Differential declaration

POS System Model Name: W5920 FCC ID: 2AH25V1SNFC, comparing with POS System Model Name: W5920 FCC ID: 2AH25V1S, there are below changes:

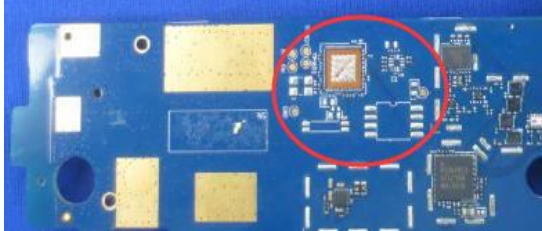
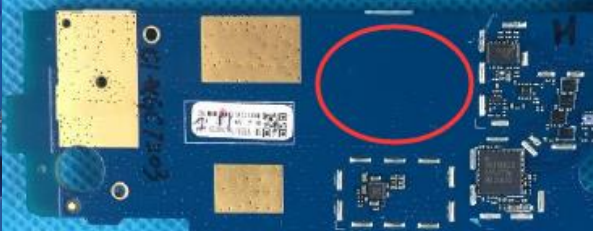
Plus the Main plate adds NFC chips and removes other useless layout part. And these don't affect RF characteristic.

Before	After
 <p>Left one is for power control part, but the PCBA is not put on W5920 FCC ID: 2AH25V1S so it is useless and we remove this layout on this application. Right part is for NFC function.</p>	
 <p>This one is for power control part, but the PCBA is not put on W5920 FCC ID: 2AH25V1S so it is useless and we remove this layout on this application.</p>
